Subject: RE: Update: Resubmission for Ashford Woods (aka Egan) for Preliminary Plan No. 120200110

Potomac Edison has reviewed the response from Soltesz, Inc. Dated October 6, 2020. Potomac Edison reviewed and discussed it's concerns with Richter and Associates (Developer Consultant) last Friday (10/23). As a result of this conversation a few adjustments are to be made to the PUE's. Below is a summary of PE's requirements for approval:

Reference: Rare, Threatened and Endangered Plant Habitat Assessment, Egan Property/Ashford

Re: RTE Plant Habitat Assessment Ashford Property (139.12 acres) North Frederick Road Montgomery County, Maryland

ATTACHMENT 1 - HABITAT ASSESSMENT MAP

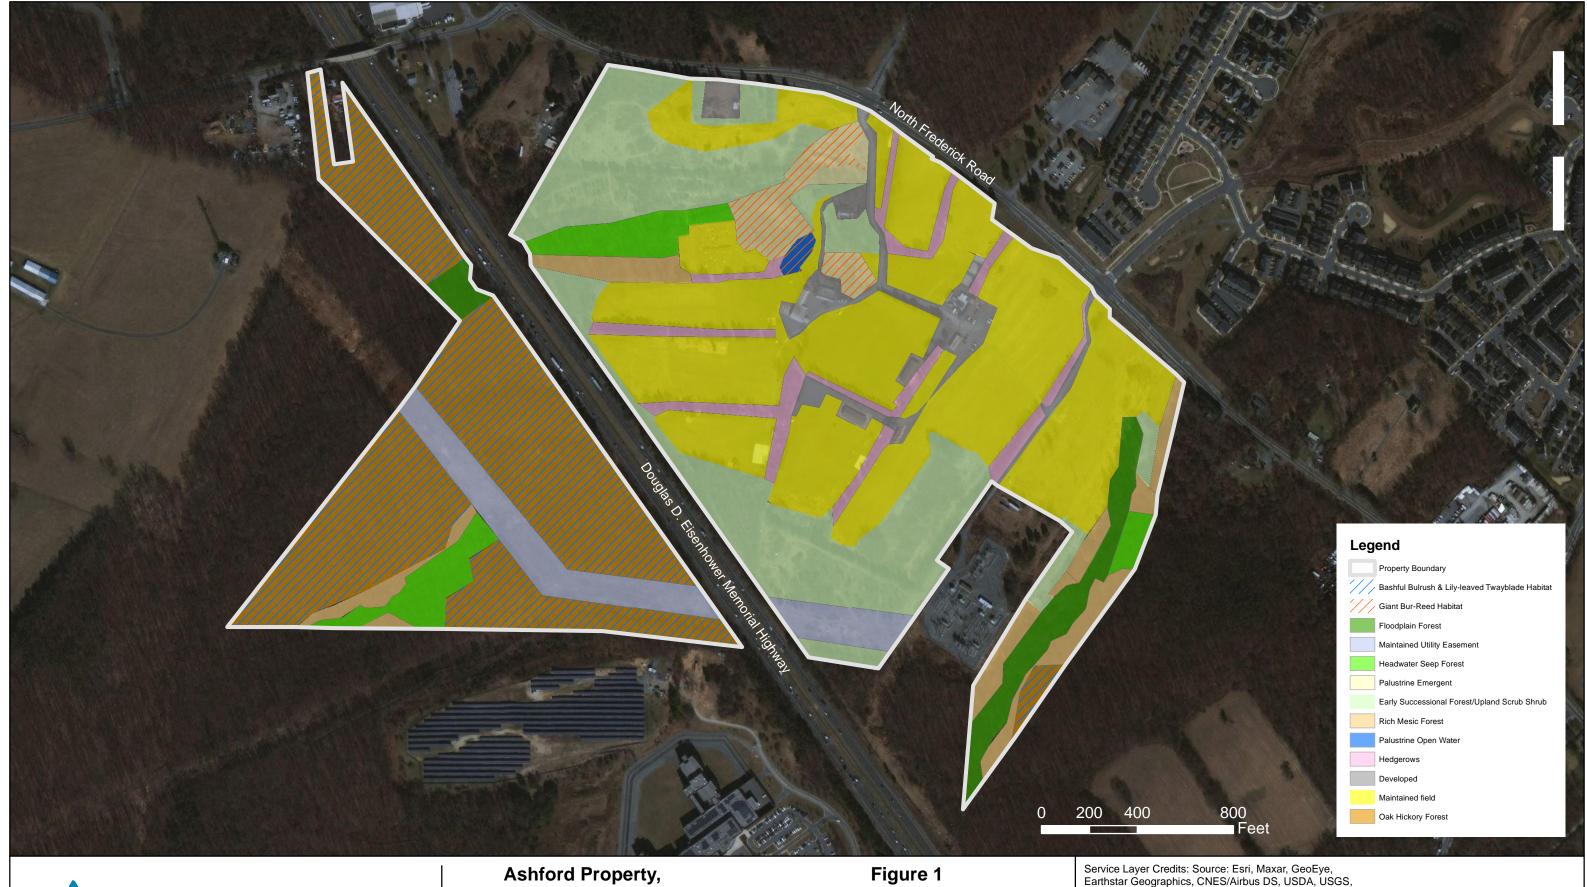
The results of Apex's habitat assessment show that potential habitat for three of the target species is present within the 139.12-acre property, including giant bur-reed, lily-leaved twayblade orchid, and bashful bulrush. Potential habitat areas for each of these species are indicated on the Potential RTE Plant Habitat Map (Figure 1) provided in Attachment 1.
